NINEWA VILLAGE ROADS
SEGMENT 3
GOVERNORATE OF
NINEWA, IRAQ

SIGIR PA-06-035
APRIL 5, 2006

SUBJECT: Report on Project Assessment of Segment 3 of the Ninewa Village Roads in
the Governorate of Ninewa, Iraq (Report Number SIGIR-PA-06-035)

Diagram 1. Typical fill cross section

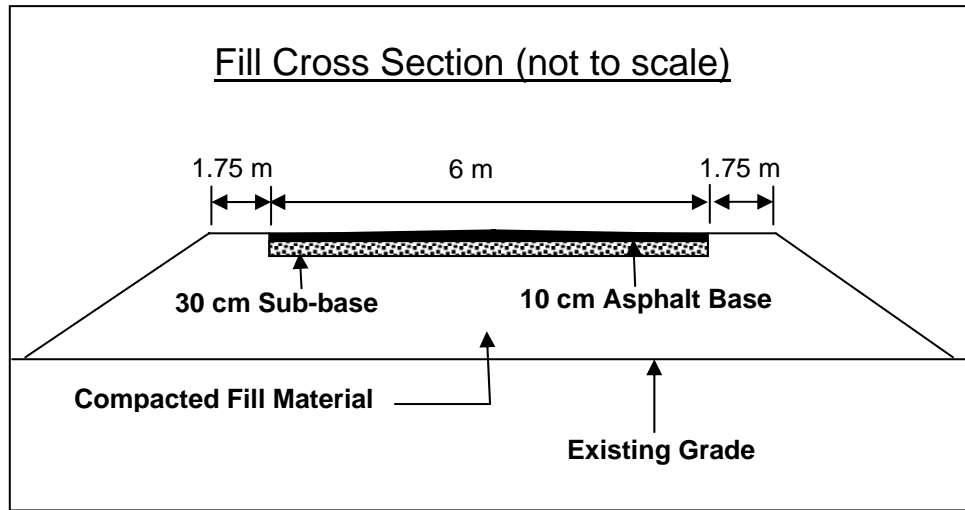
The contract BOQ included requirements for earthwork cut and fill sections. For fill sections, the contractor was required to clear and grub the natural ground to a depth of 10 cm and provide new suitable fill material compacted in layers of 20 cm to reach the profile contained in typical design cross section. For an illustration of a typical fill cross section, see Diagram 1.

Diagram 2. Typical cut cross section

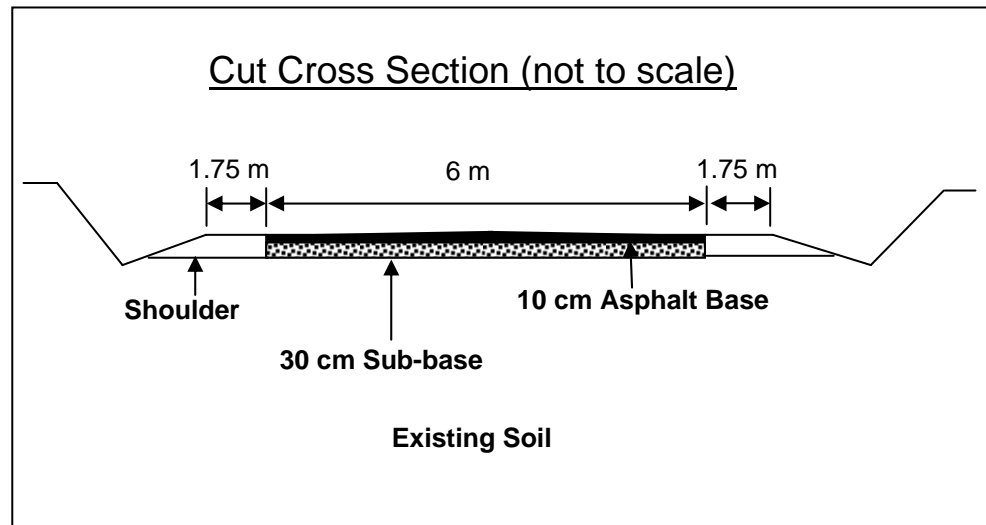
On a cut section, unneeded materials are removed so as to match the elevations provided in the design profile. Diagram 2 provides an illustration of a typical cut section.

Based on the review of the contract and our observations on site, the cut and fill sections appeared to meet the requirements of the contract.
